SUNDRY NOTICES AND REPORTS ON WELLS JUN 20 2016
Do not use this form for proposals to drill or to re-enter an abandoned well. Use form 3160-3 (APD) for such proposals.

PROPOSED PA PROCEDURE:

Well Name: SKELLY UNIT 088

Permanent Abandonment of Federal Wells
Conditions of Approval (LPC Habitat)

NM Schematic

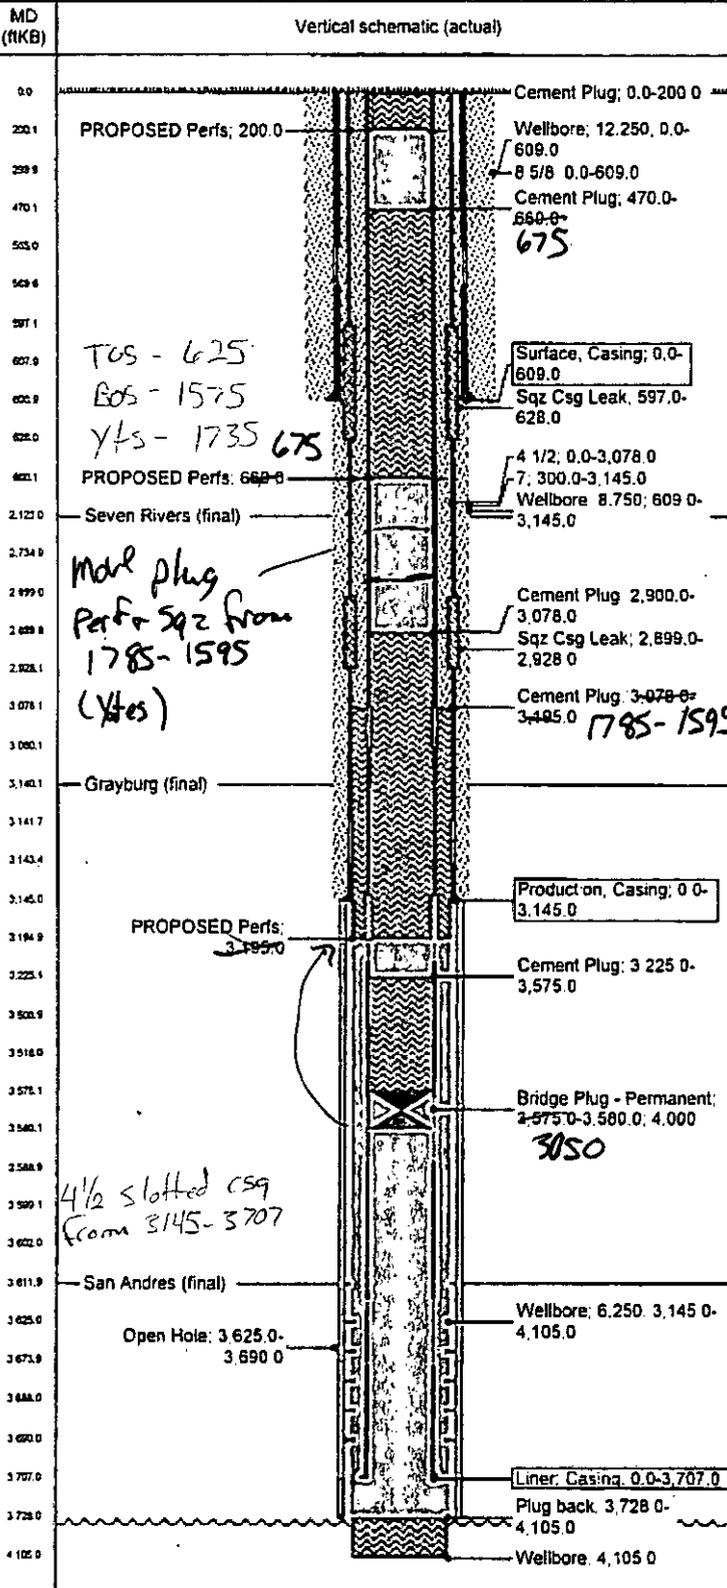
- MIRU PLUGGING EQUIPMENT
- SET 4 1/2 CIBP @ 3673' W/25 SX CMT ^{3050'}
- CIRCULATE HOLE WITH MUD LADEN FLUID
- PERF & SQZ 40 SX CMT @ 3135' WOG & TAG → Move plug Perf & SQZ from 1785 - 1595'
- PERF & SQZ 25 SX CMT @ 800' WOG & TAG → 675 - 470
- PERF & SQZ 55 SX CMT @ 200 & CIRCULATE TO SURFACE
- CUT OFF WELLHEAD & WELD ON DRY HOLE MARKER

Description Cement Plug	Top (ftKB) 3,078.0	Btm (ftKB) 3,195.0	Eval Method	Comment PROPOSED: Perf and Sqz 40 sks cmt at 3195' WOC and Tag.	
Description 8 5/8	Top (ftKB) 0.0	Btm (ftKB) 609.0	Eval Method Returns to Surface	Comment	
Description 7	Top (ftKB) 300.0	Btm (ftKB) 3,145.0	Eval Method CBL	Comment	
Description Plug back	Top (ftKB) 3,728.0	Btm (ftKB) 4,105.0	Eval Method	Comment	
Description Sqz Csg Leak	Top (ftKB) 597.0	Btm (ftKB) 628.0	Eval Method	Comment	
Description Sqz Csg Leak	Top (ftKB) 2,899.0	Btm (ftKB) 2,928.0	Eval Method	Comment	
Description 4 1/2	Top (ftKB) 0.0	Btm (ftKB) 3,078.0	Eval Method Returns to Surface	Comment	
Tubing Strings					
Tubing Description Tubing	Set Depth 3,727.0	Run Date 9/28/1942	Pull Date 4/1/1943		
Tubing Description Tubing	Set Depth 3,727.0	Run Date 4/9/1943	Pull Date 10/1/1957		
Tubing Description Tubing - Production	Set Depth 3,650.0	Run Date 6/11/1983	Pull Date 9/11/1995

Tubing Description Tubing - Production	Set Depth 3,660.0	Run Date 9/11/1995	Pull Date 4/9/1997		
Tubing Description Tubing	Set Depth 3,099.0	Run Date 4/10/1997	Pull Date 6/1/2016		
Perforations					
Top (ftKB) 200.0	Btm (ftKB) 200.0	Comment			
Top (ftKB) 660.0	Btm (ftKB) 660.0	Comment			
Top (ftKB) 3,195.0	Btm (ftKB) 3,195.0	Comment			
Top (ftKB) 3,625.0	Btm (ftKB) 3,690.0	Comment			
Other In Hole					
Des Bridge Plug - Permanent	Top (ftKB) 3,575.0	Btm (ftKB) 3,580.0	Run Date	Com PROPOSED: Set CIBP at 3575' and cap with 25 sks cmt.
